Addendum: **3**

Project: **FWCS Fairfield Elementary School Restroom Renovations 2025**

**Addendum D3**

re: **FORT WAYNE COMMUNITY SCHOOLS**  
**Fairfield Elementary School**  
**Restroom Renovation 2025**  
 MPG No. 111029.00

DATE: 12/09/2024  
COMM: 111028  
FILE:  
SCHOOL: Fairfield Elementary School  
2825 Fairfield Ave  
Fort Wayne Indiana 46807  
TITLE:  
**Basement, First Floor, & Second Floor Demolition & Floor Plans**  
SHEET:

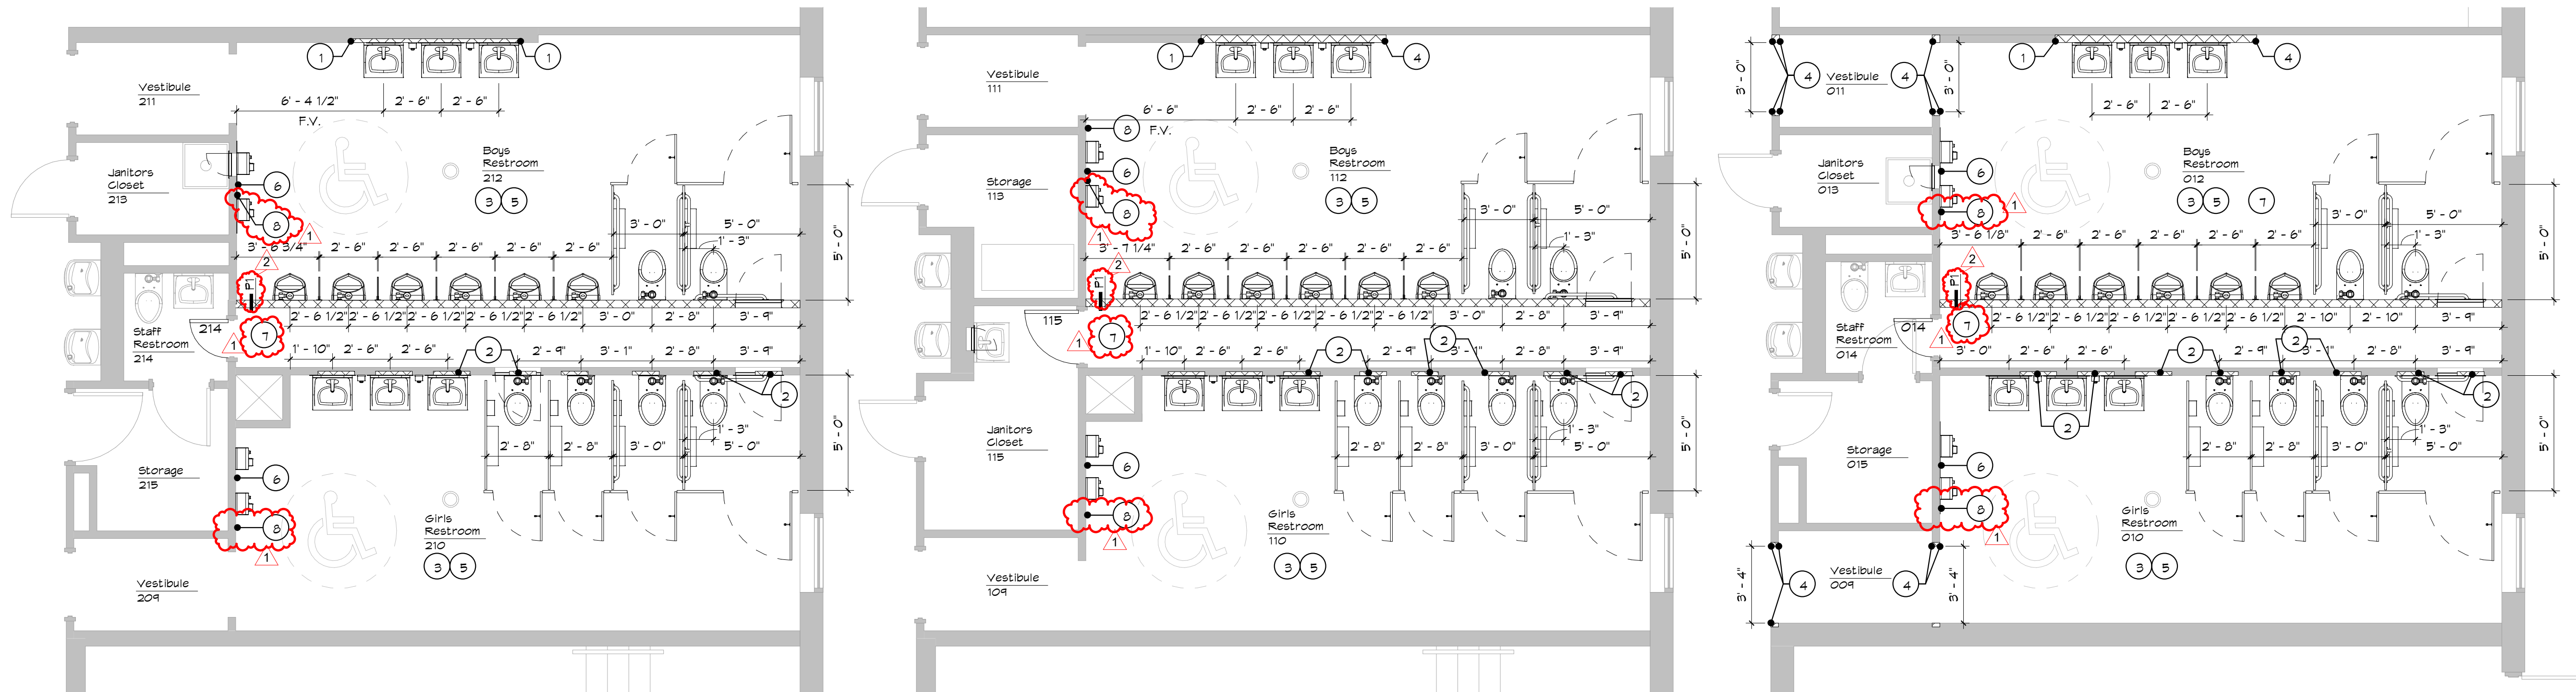
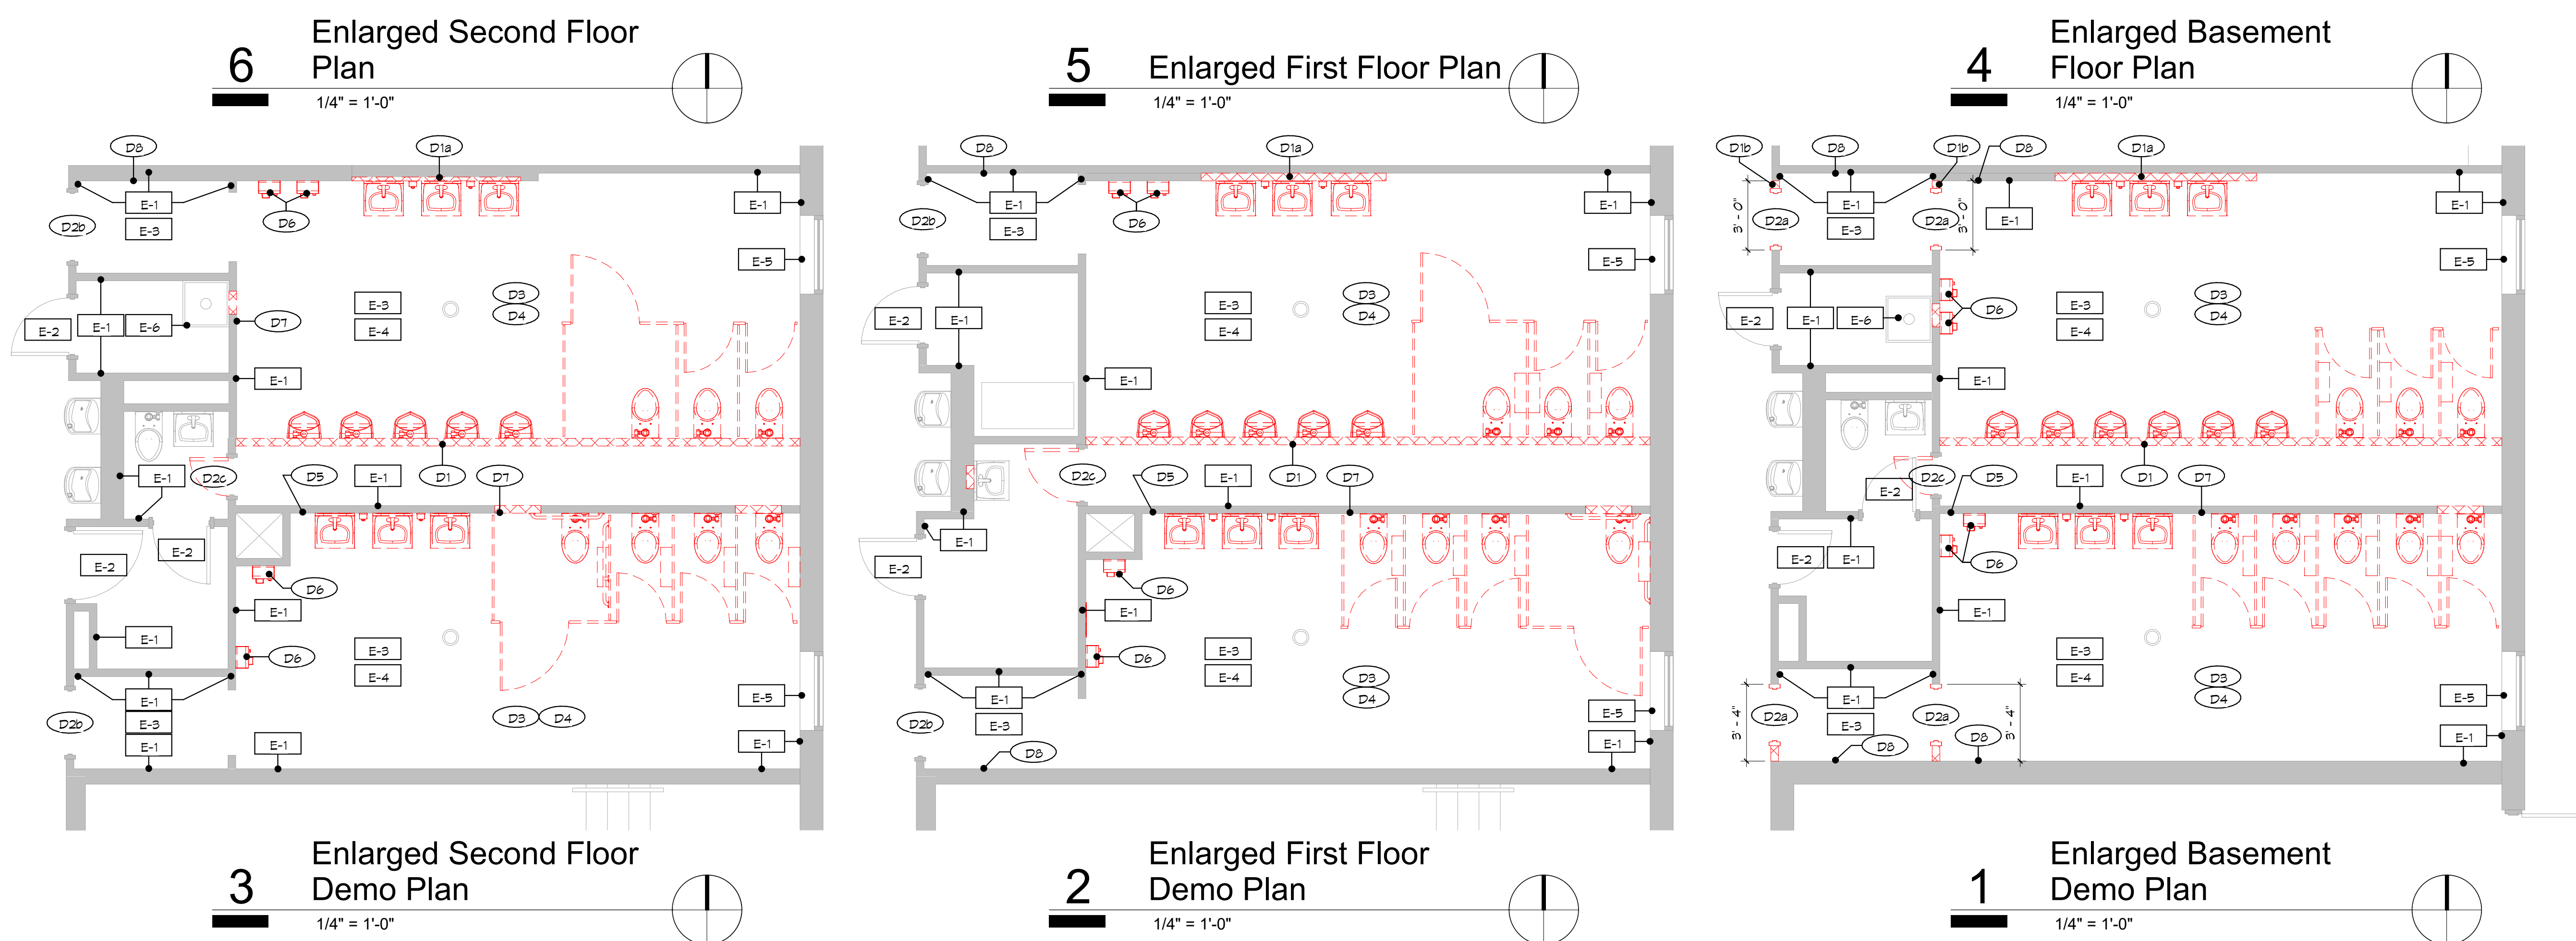
ITEM	LOCATION	DESCRIPTION
A3.01	DRAWING A2.0 <b>(Drawing Reissued)</b>	<b><u>ADD:</u></b> Reissue attached Sheet A2.0 Basement, First Floor, & Second Floor Demolition & Floor Plans reissued. See P1 – Partition Type detail and Floor Plan Legend.
